**Design Review/Preservation Board
Sacramento, California**

**SUBJECT: NW corner 10th & T Streets
Office Building-New Construction
South Side Preservation Area
(APN: 010-0072-009-012)(PB91-006)**

sheet title **SITE PLAN**
FLOOR PLAN
sheet no.

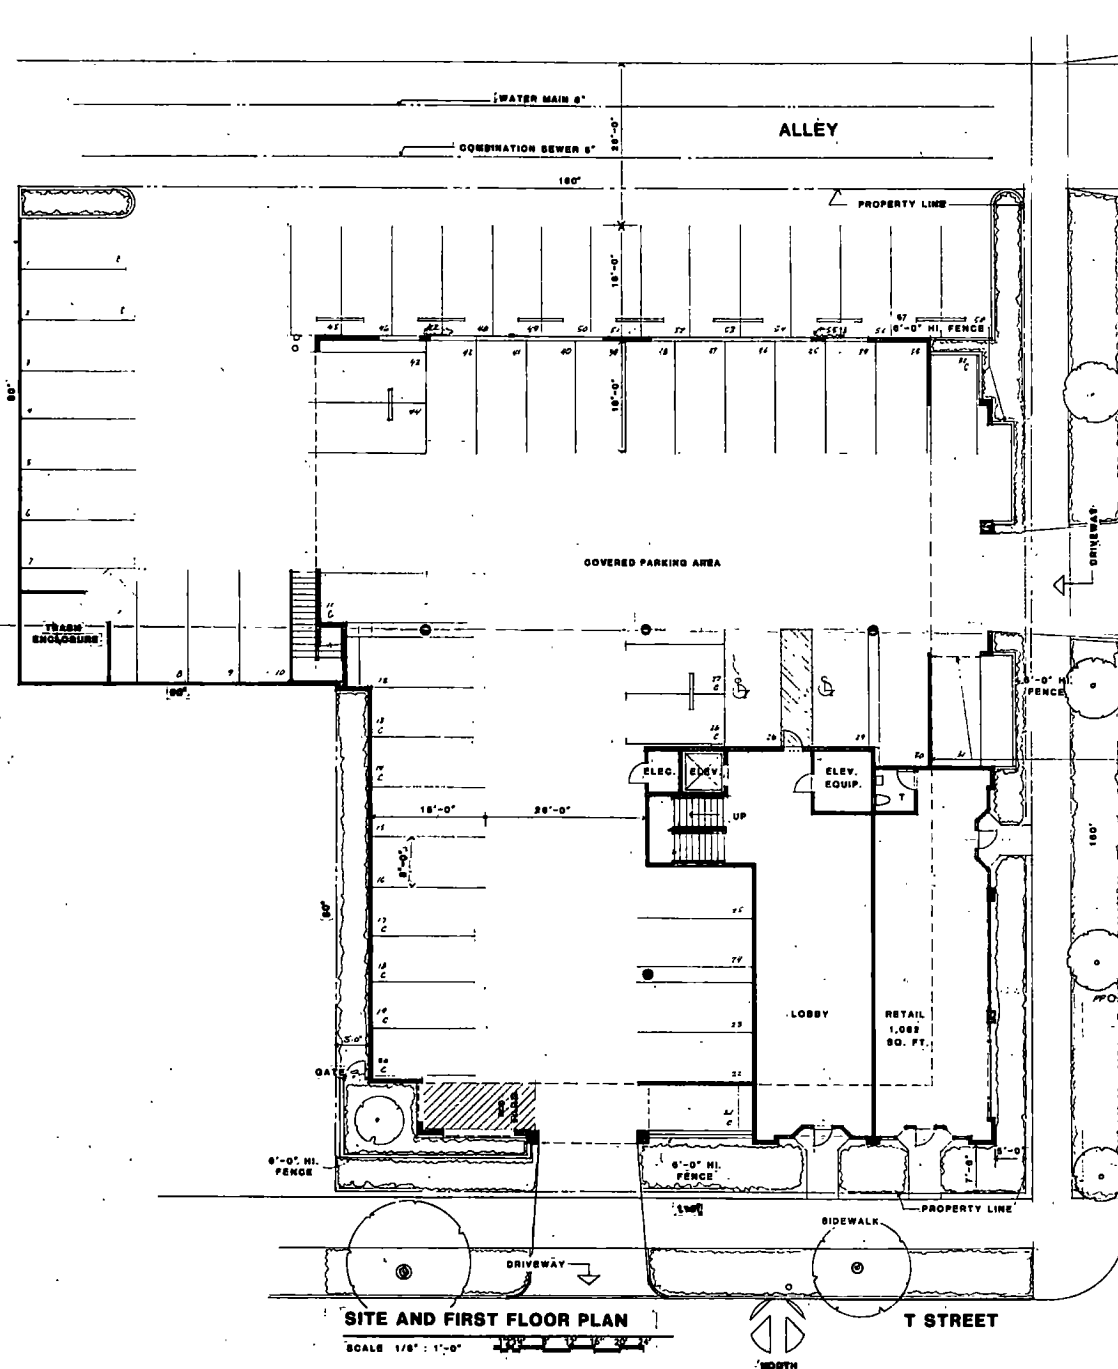
At the T Street driveway (one-way out), a paved area behind the screening wall and adjacent to parking space 20C needs to be modified so as not to be confused as a parking space. A portion of that area needs to be retained to provide adequate maneuvering area for parking space 21C. However, the rest should be utilized as a planter area to prevent its use for parking. The portion retained as maneuvering area should be striped and further protected with a "Keep Clear", or "No Parking" sign.

The site plan/first floor plan has been revised to include only a painted cross-hatching and "No Parking" on a paved surface. Staff would still prefer a physical obstacle to parking in that location. The applicant has suggested storage in lieu of planting. Staff is not supportive to unspecified storage that may ultimately become an eyesore for parkers or pedestrian viewing into the parking lot. However, the need for bicycle storage could be met at this location. This may be the only available space for that function. Staff could work with the applicant in the development of this area for planting, storage or a combination of both. A selection of low-light planting materials may be necessary.

The wheel stops for parking spaces 26C, 27C, 43, and 44 are not properly positioned.

7. The open parking area along the alley and to the west of the building has very little landscaping. Only end planters are provided. One is on the alley. One is along the back of sidewalk on 10th Street.
 - a. The two-foot overhang area for parking spaces 1 through 10 should be utilized as planter area. In these planters the provision of climbing vines would serve to soften the appearance of the masonry walls that is required along the west and south interior property lines. These planters should be extended to provide screening of the trash enclosure.
 - b. The north side of the building is open to the ground floor parking. The smaller openings on the ends will have grill work and are indicated on the site plan and

north elevation plan with a small tree in front of each of them. They would be located within the two-foot overhang area of the parking spaces. The trees are not indicated on the landscape and irrigation plans. The two large openings in the center have no screening at all of the view into the parking garage. What will be visible after hours will be the asphalt paving surface continuing from the alley and into the parking garage, the inside wall surfaces of the parking garage, and the prefabricated wheels stops. A continuous planter is needed along this edge of the building. The view into the parking garage would be softened. The stilt-like appearance of the the north building facade, as viewed from the alley, property to the north of the alley, and from the adjacent 10th Street right-of-way would be lessened.

1. The paved area adjacent to parking space 20C shall be modified with provision of a landscape planter, a bicycle storage area, or a combination of both. A striped and signed maneuvering area for space 21C must still be provided.

2. The wheel stops for parking spaces 26C, 27C, 43, and 44 shall be positioned on revised plans in conformance with the Zoning Ordinance.
3. Planting shall be provided in the overhang area of parking space 1 through 10. The planter shall contain climbing vines and shall continue along the sides of the trash enclosure. A continuous planter shall also be located along the north edge of the building, utilizing the overhang area of both covered and uncovered parking spaces along that side of the building. Besides the trees indicated on the site plan and on the north elevation drawing, planting shall include ground cover and small shrubs. To avoid damage from vehicles as much as possible, the line of trees and shrubs shall be

within the overhang area of the uncovered row of parking spaces, with the centers of those plants aligned with the striping between the uncovered parking spaces.

ROOF PLAN

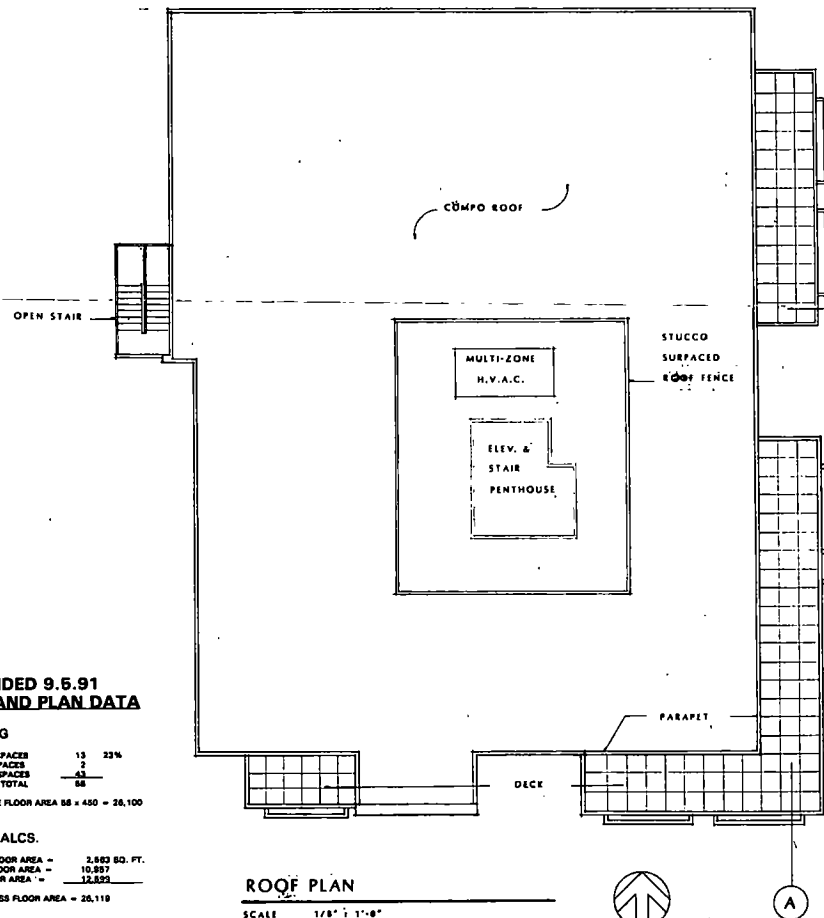
3. The applicant has also responded to the Board's direction to provide a roof plan and some details of the facade treatment. The roof plan does not specify the material to be used for the third floor deck.
4. No sign program has been provided for review and approval of the Board.
5. In the August 7, 1991, staff report, staff indicated that:

SITE AND FIRST FLOOR PLAN

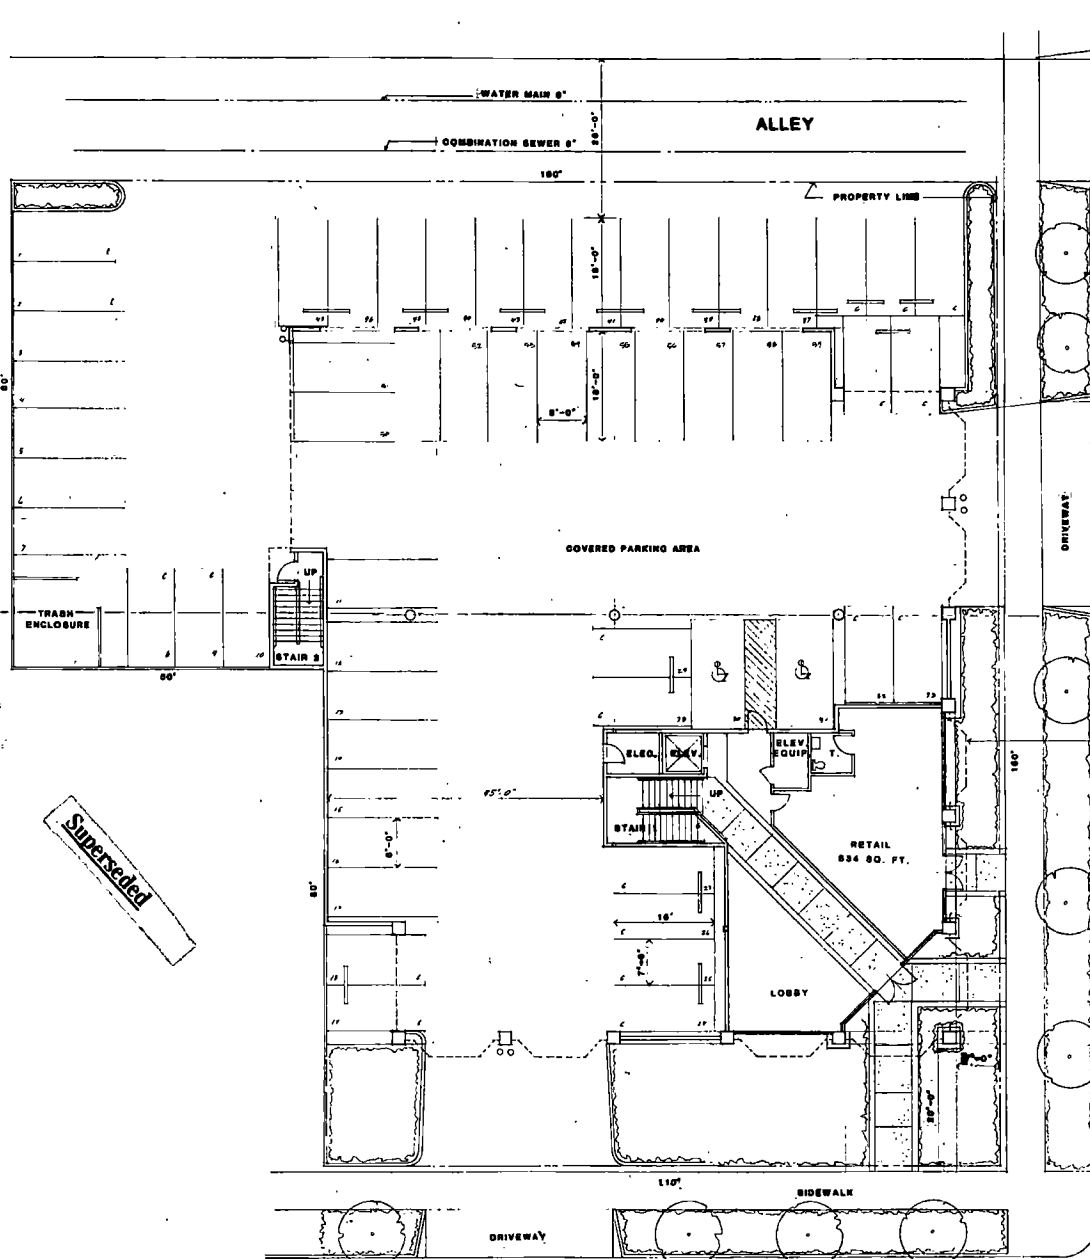
5. At the T Street driveway (one-way out), a paved area behind the screening wall and adjacent to parking space 20C needs to be modified so as not to be confused as a parking space. A portion of that area needs to be retained to provide adequate maneuvering area for parking space 21C. However, the rest should be utilized as a planter area to prevent its use for parking. The portion retained as maneuvering area should be striped and further protected with a "Keep Clear", or "No Parking" sign.

1. Further meeting(s) with the neighborhood association, if needed, should be held by the applicant to mitigate their design concerns.
2. The paved area adjacent to parking space 20C shall be modified with provision of a landscape planter and a striped and signed maneuvering area.
3. The applicant shall modify the design to meet any remaining concerns of the Board.

SITE PLAN
SCALE: 1/8" = 1'-0"

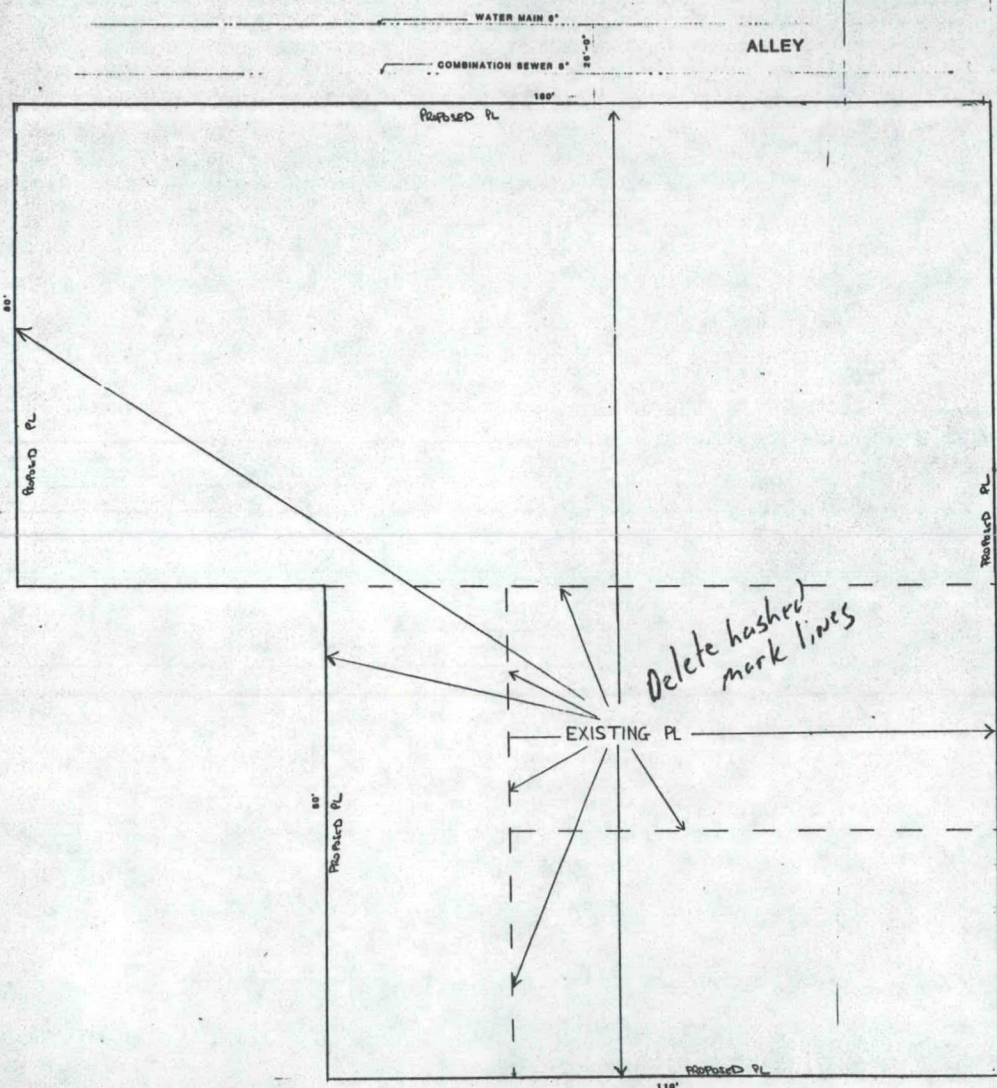
Delete hashed
mark lines
